SAN FRANCISCO PLANNING DEPARTMENT

Addendum 3 to Environmental Impact Report

Date: September 19, 2014
Case No.: **2007.946E**
Project Title: **Candlestick Point-Hunters Point Shipyard Phase II**
EIR: 2007.946E, certified June 3, 2010
Project Sponsor: Lennar Urban
Lead Agency: San Francisco Planning Department/Office of Community Investment & Infrastructure
Staff Contact: Joy Navarrete – (415) 575-9040
joy.navarrete@sfgov.org

FIGURE 1

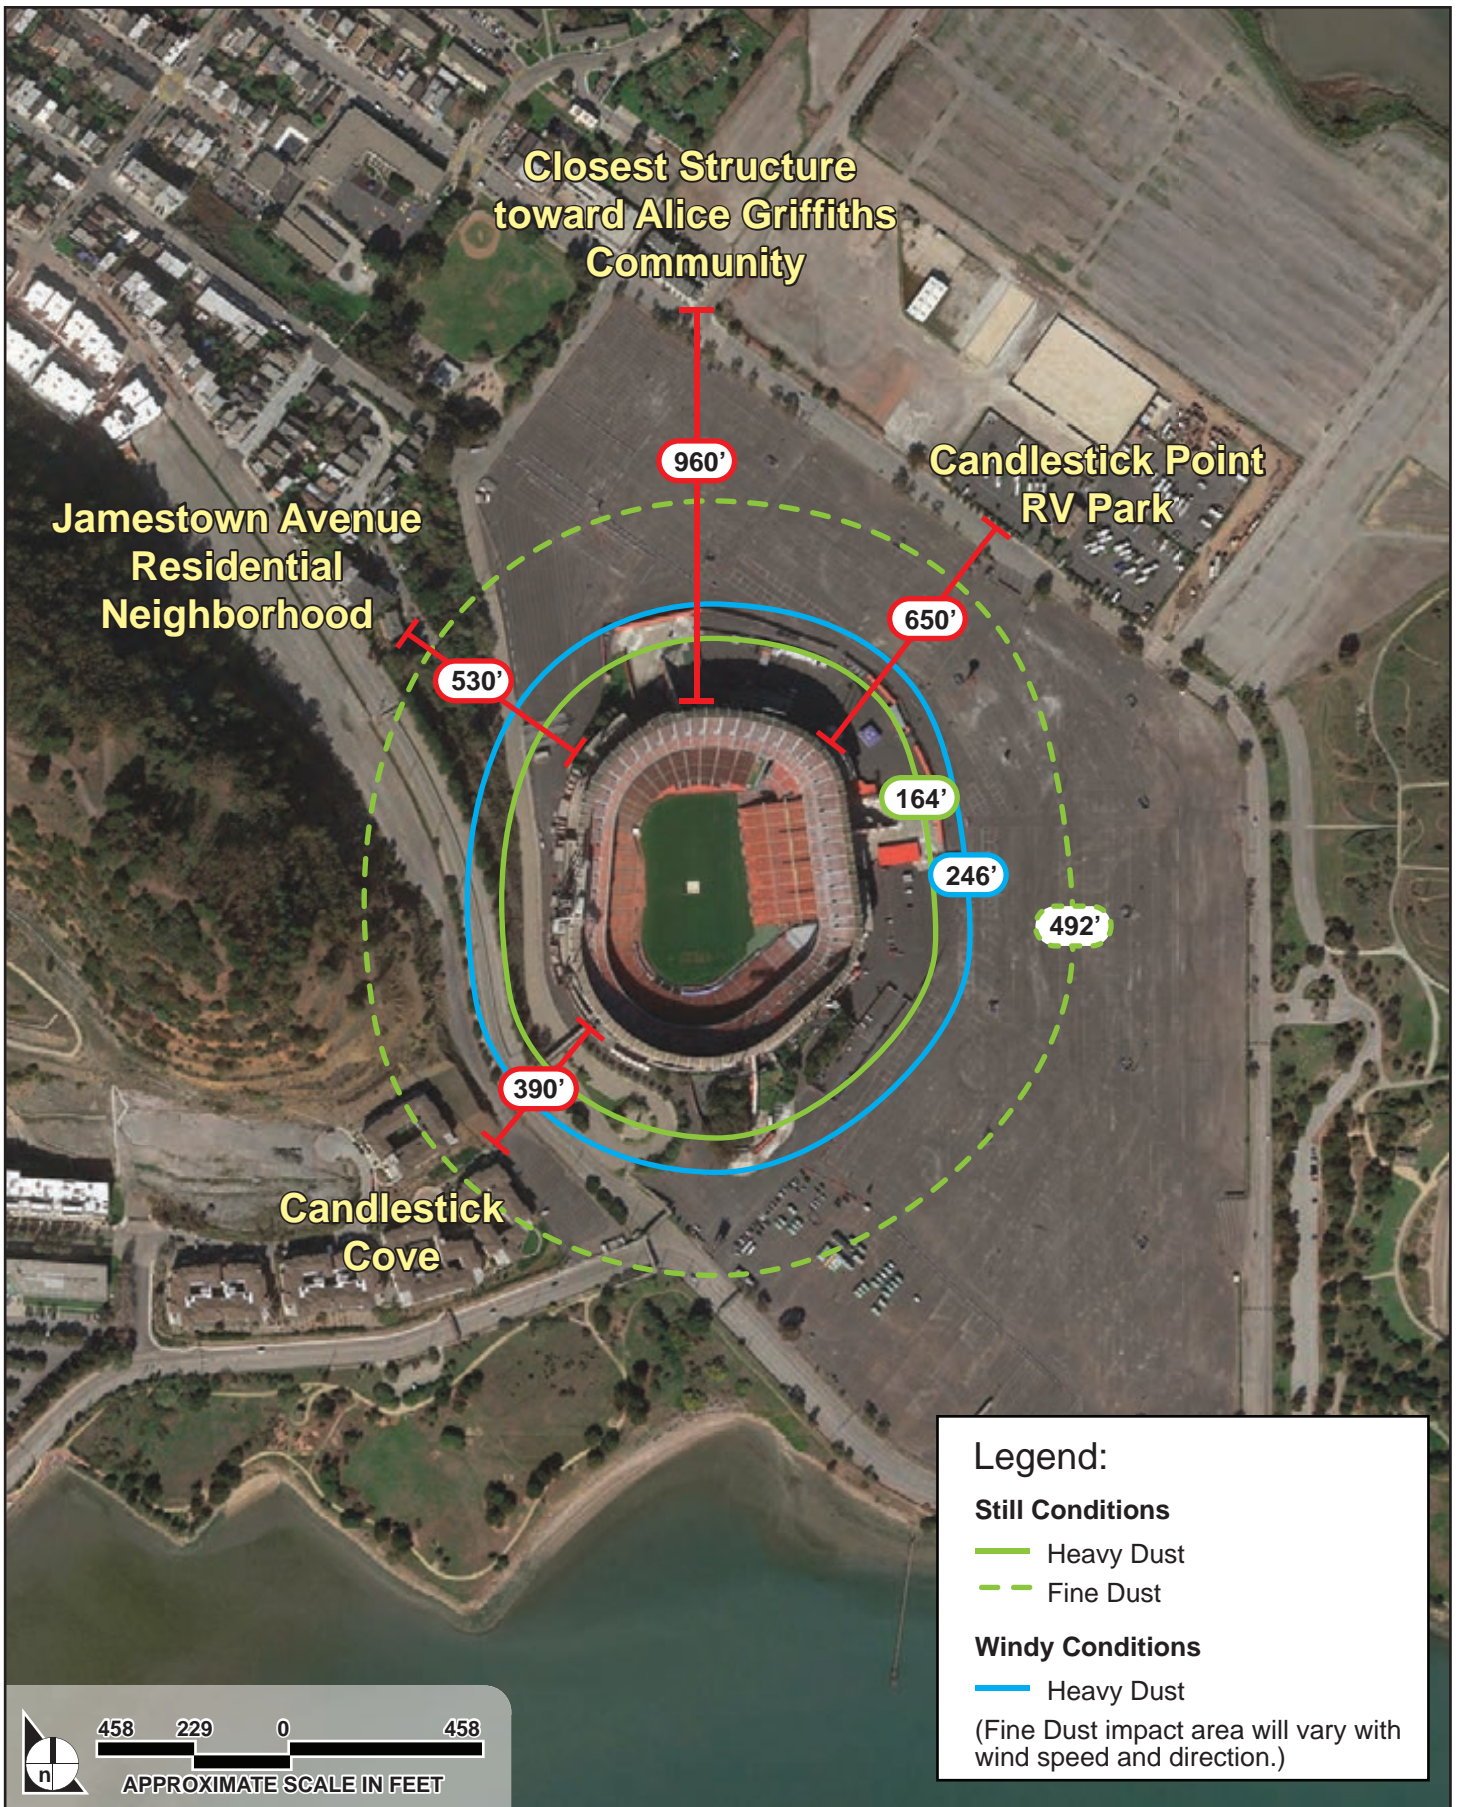
While implosion would result in dust for a shorter period of time, dust would be dispersed over a wider area as shown in **Figure 1**. Demolition that occurs in still air, for a structure the size and open configuration of the stadium, the majority of the large particulate dust would precipitate within 50 meters (164 feet) of the outside perimeter of the stadium. Due to the distance between this area and the nearest off-site structures, no off-site receptors would be affected by large particulate dust under the anticipated implosion schedule and circumstances currently envisioned. Given the high humidity in the Bay area, in still air, fine dust could travel as much as 150 meters (492 feet). As shown in **Figure 1**, this area of effect is largely limited to the stadium site and other than a small portion of Candlestick Cove development, there are no receptors within this area of effect. If weather conditions at the time of the implosion include wind, the large particle dust are expected to precipitate within approximately 75 meters (246 feet) downwind of the structure (see **Figure 1**) and fine dust would remain suspended in the air for several minutes more. Depending on wind velocity, the wind would disperse the remaining fine dust out over a larger area. The distance the fine dust would travel would be a direct function of wind speed at the time of the implosion. Given the prevailing winds at Candlestick Point which are from the west, the dust cloud would travel over the stadium parking lot and then out to the bay, where it would disperse. To address the contingency that winds could shift and some of the finer particles could be dispersed in a landward direction, as part of the DCP, all nearby sensitive receptors would be informed of the implosion and asked to take necessary precautions (e.g., remain indoors, close windows).

In the case of implosion, the DCP additionally shall include provisions to achieve the Article 22B goal of minimization of visible dust exposure:

- **Remove dust-generating material prior to implosion, including, without limitation, performing an interior strip out to remove such items as copper, non-structural steel aluminum, dry wall, carpet, window glazing, timber, furniture, fixtures, and equipment. Remove brick and concrete block.**

- **Implement a community outreach program to identify potentially affected sensitive receptors and equipment and to work with receptors and businesses to minimize dust exposure during implosion event, by assisting receptors to stay indoors or to evacuate from the affected area.**

- **Coordinate with facility managers in the affected area to control dust entry into buildings during event.**
- **Implement prompt dust cleanup measures after event; station clean-up crews, including street sweepers, window washers, water trucks and similar equipment and personnel in the area prior to event to facilitate immediate cleanup.**

- **Undertake implosion only during advantageous weather conditions with minimal wind speed and minimal wind movement toward sensitive receptors**
- **Prior to implosion, encase site with a chain link fence and fabric to minimize large particles from leaving the site**

- **Protect stormwater inlets from dust**
